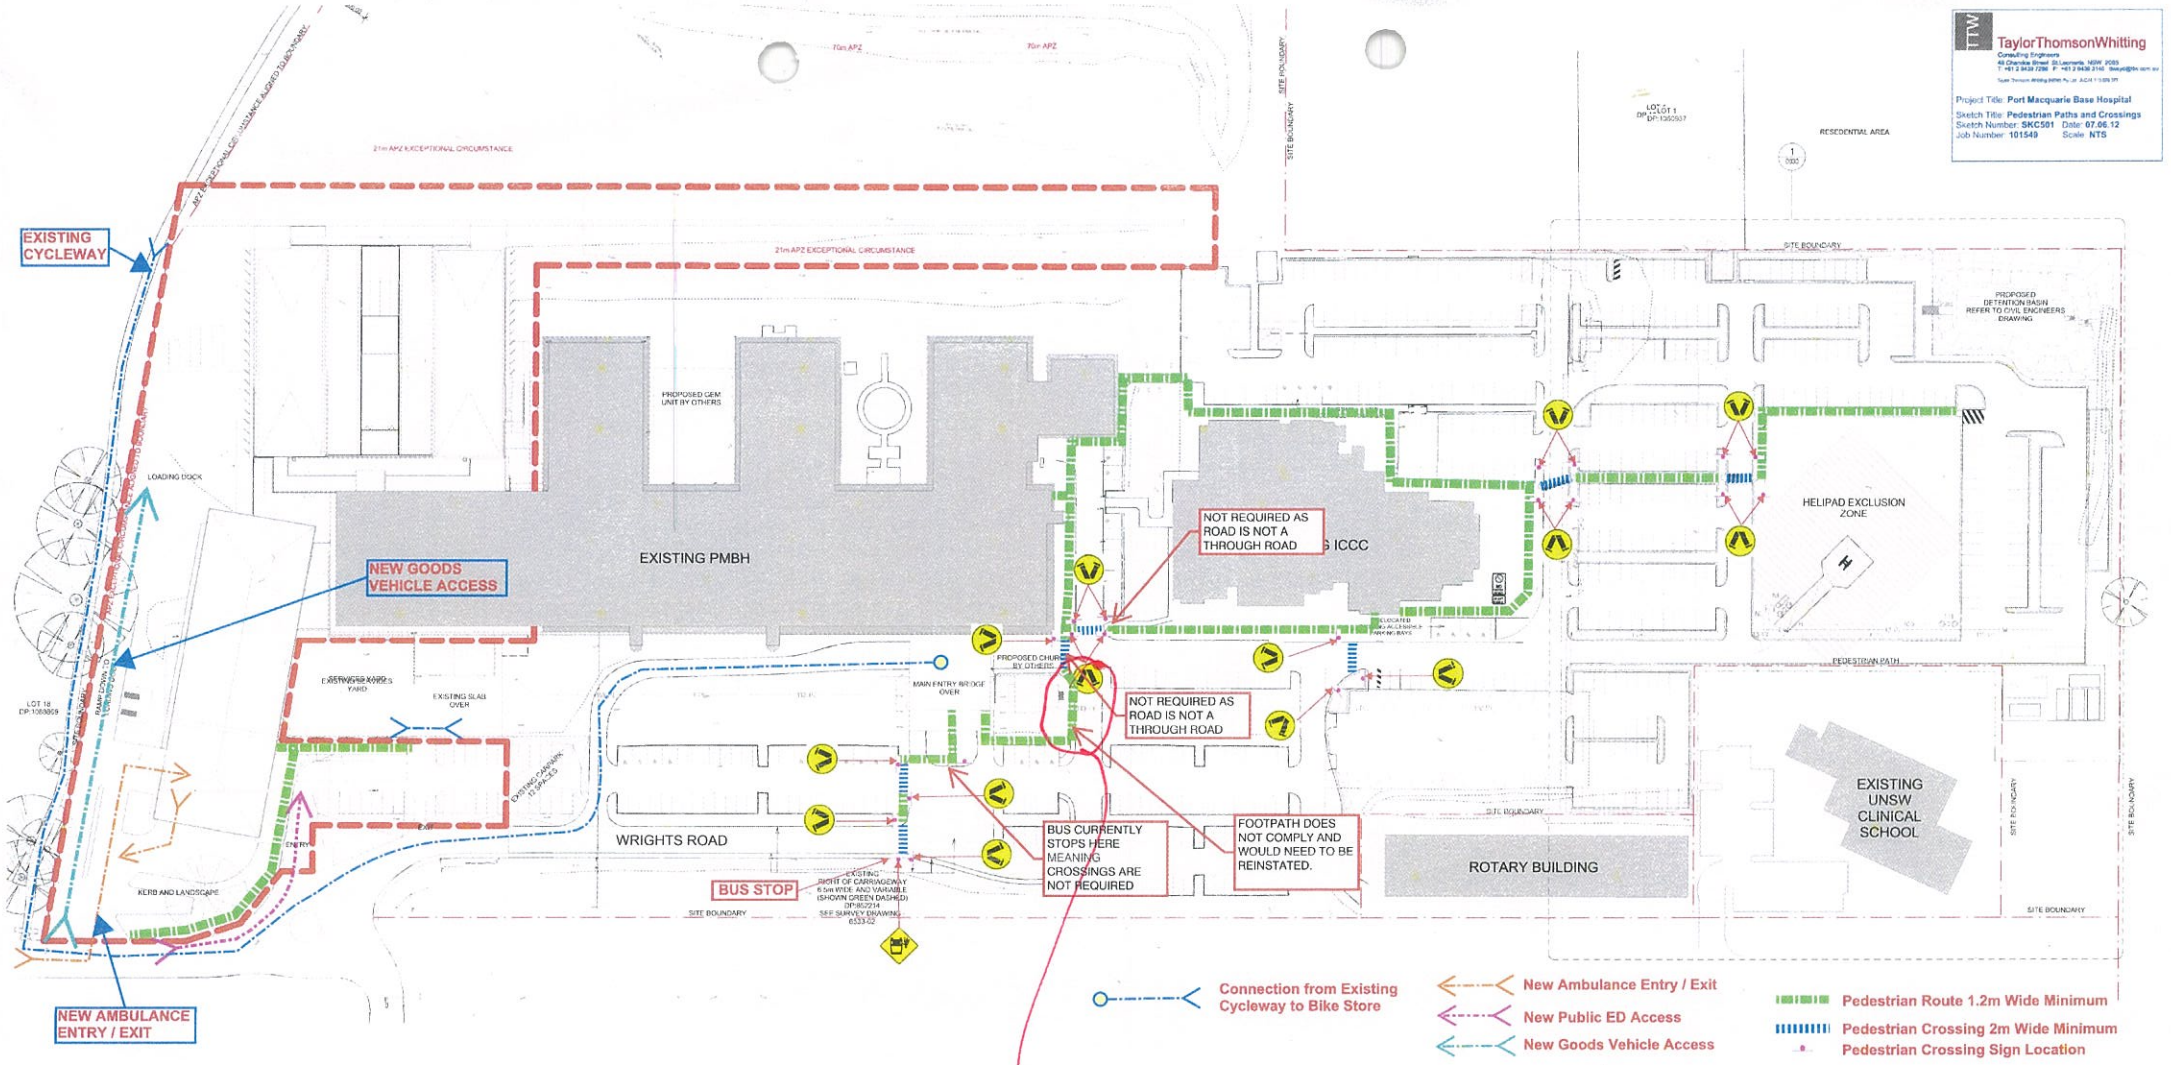
this section of footpath does not meet DDA reqm'ts eg. gradient + width.
To achieve the gradient we would need to construct a series of ramps which would necessitate use the vacant area which is "ear marked" for the hospital's future chapel.
